NO. 16-095

SUBJECT: GRIFFITH PARK CRYSTAL SPRINGS - NEW BASEBALL FIELDS (W.O. #E170110B) PROJECT - PROPOSED PROJECT CHANGES; ADDENDUM TO PREVIOUSLY CERTIFIED ENVIRONMENTAL IMPACT REPORT

Griffith Park Crystal Springs New Baseball Fields Project
(W.O. #E170110B)

Addendum to the Environmental Impact Report

**GRIFFITH PARK CRYSTAL SPRINGS YOUTH BALLFIELD
REVISED PROJECT LAYOUT**

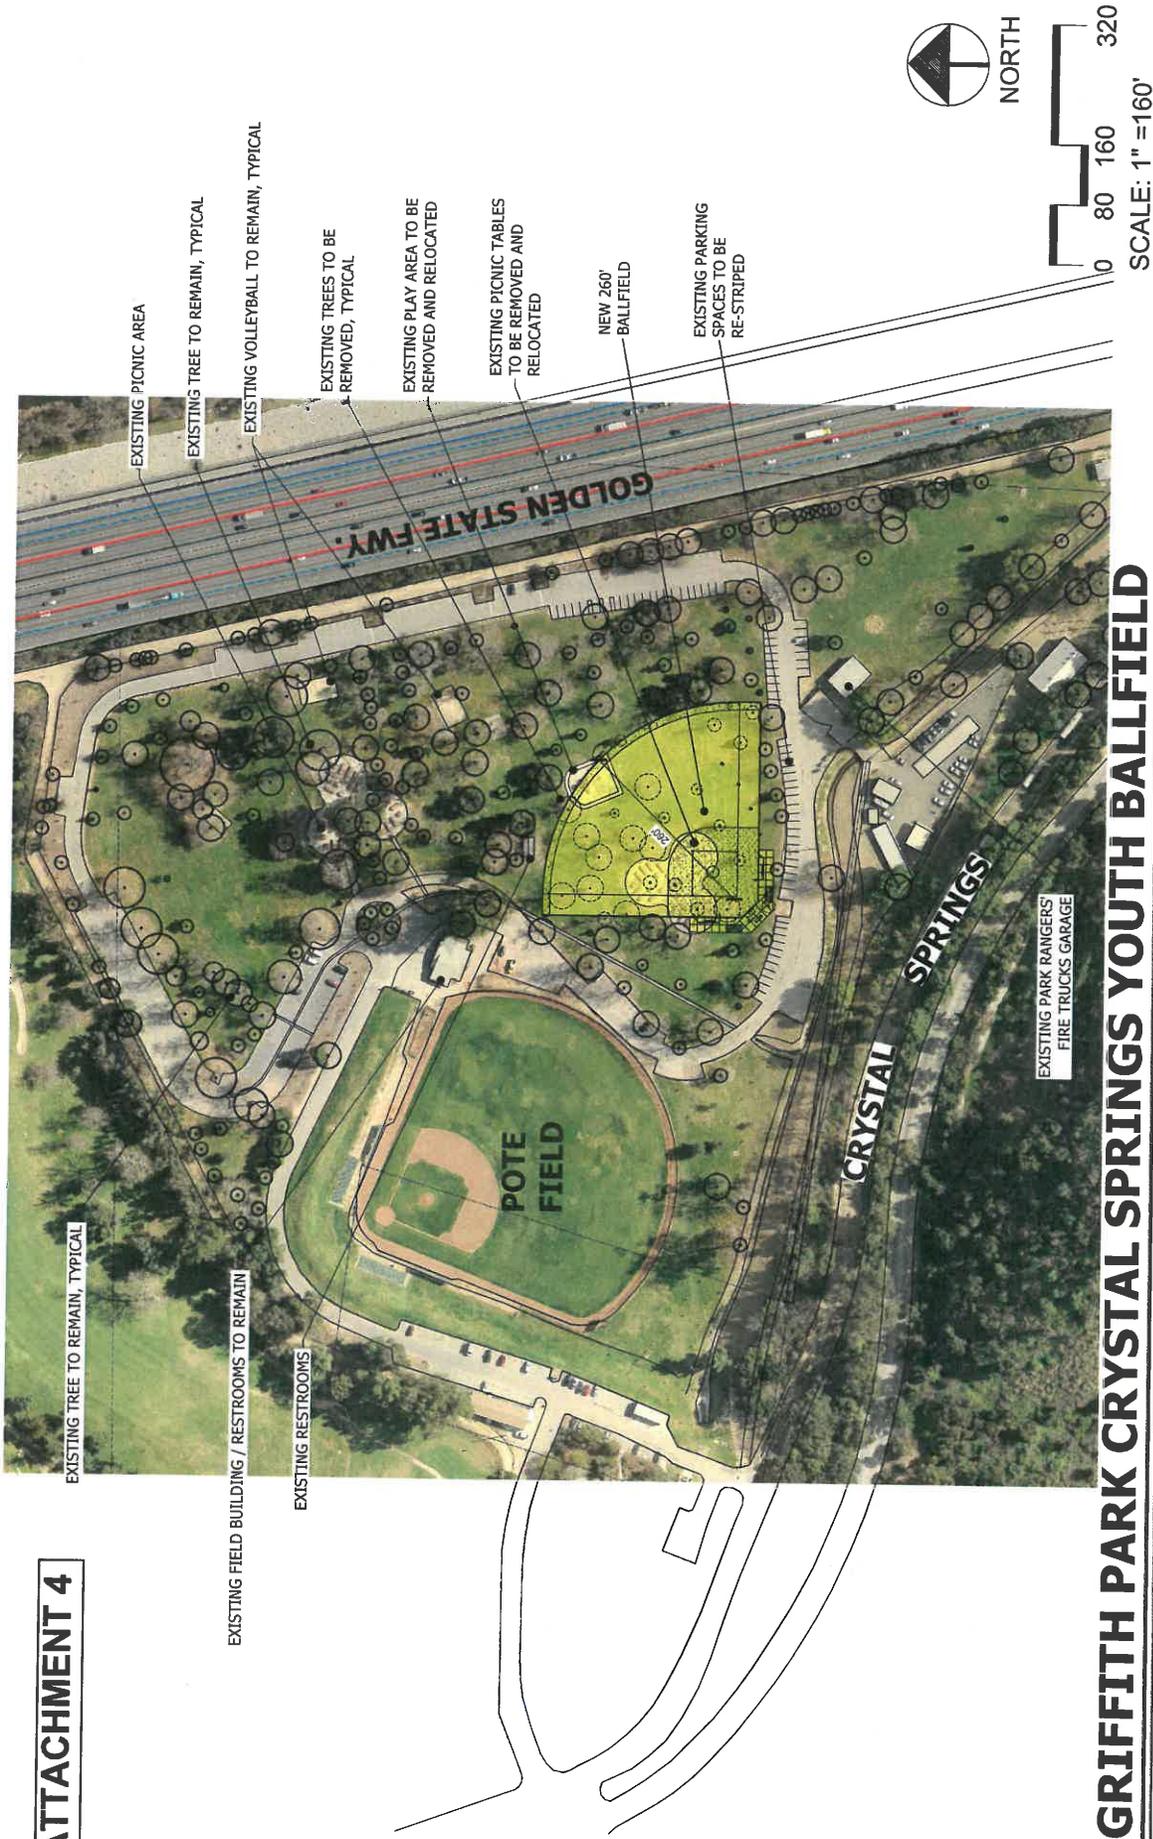
Under the contingent settlement, the Project would be changed to construct only one new youth baseball field at the Crystal Springs Picnic Area, instead of two fields. This field would be located, as depicted in Attachment 4 to this Report, in a portion of the previously described Project site for EIR Alternative 1B. The single field would be larger in size, measuring 260 feet from home plate to the centerfield fence, which would be up to 30 feet high. Changes to the existing access loop driveway and the related reduction in parking spaces in the original project would be eliminated. With the project changes, approximately fifty-six (56) picnic tables and a children's play area would be relocated. The number of trees required to be removed and replaced would be reduced to approximately thirty-two (32) generally small trees, and the heritage Sycamore tree would not be required to be removed.

Subsequent to the certification of the EIR, the Bureau of Engineering revised the design of the project (Revised Project). The Revised Project would construct one (1) new youth baseball field on approximately 2.1 acres within the southern portion of the existing Crystal Springs Picnic Area. The single field would measure 260 feet from home plate to the centerfield fence which would be up to 30 feet high. As with the Proposed Project, the field would have natural grass and a dirt playing surface, two (2) dugouts, bleachers, outfield and perimeter fencing, and scoreboards. The Revised Project also includes landscaping, an irrigation system, ADA path of travel, and security lighting. There would be no changes to the access loop driveway and no reduction in the number of parking spaces. Approximately fifty six (56) picnic tables and the children's play area would have to be relocated. The Revised Project would result in the removal and replacement of approximately 32 trees. The constructed baseball field would be operated and maintained by the Department of Recreation and Parks (RAP).
